Lake Michigan Shoreline Protection at Promontory Point (Old ProjID:0109170043WCK)
54th to 57th St.

COEC,
IHPA Log #043091701

July 25, 2005

TYPICAL SOUTH FACING SECTION

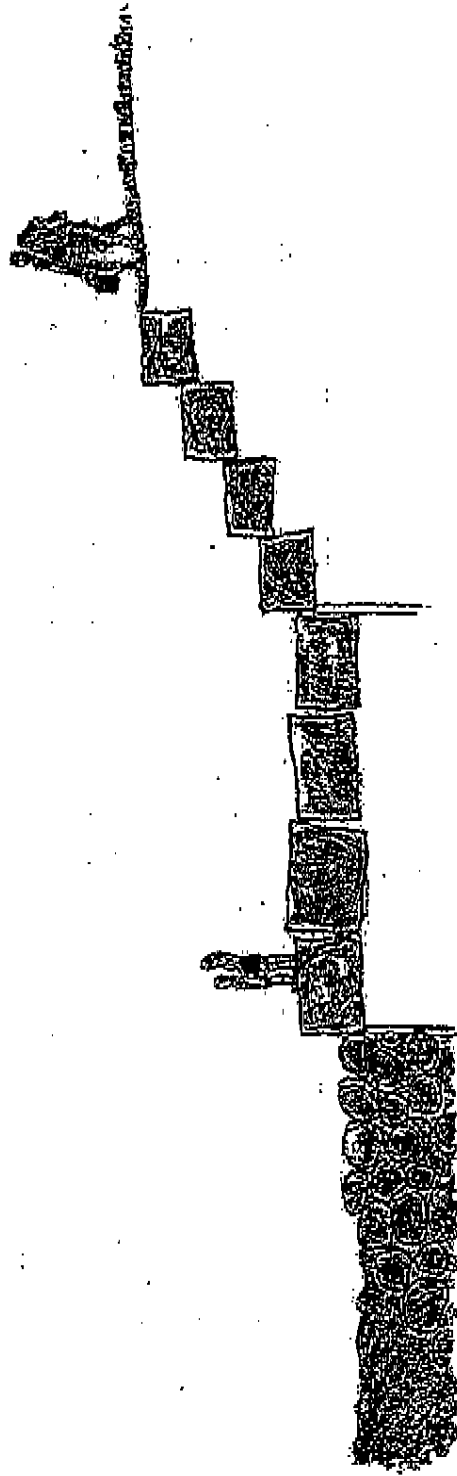
- The design for the new concrete/stone revetment for the other areas of Promontory Point should meet the following criteria:

1. The top stone edge should approximate the location of the existing stone edge.
2. ~~There should be two steps utilizing the existing limestone blocks.~~
3. The overall width of the revetment should closely match the existing dimension.
4. The sheet pile should be covered with stone along the lake. * *see page 20*
5. The design of the vertical surface of the concrete revetments should use a form liner to replicate the appearance of existing stone blocks. (The IHPA is currently working with the Corps of Engineers to approve a design for this concrete treatment.)
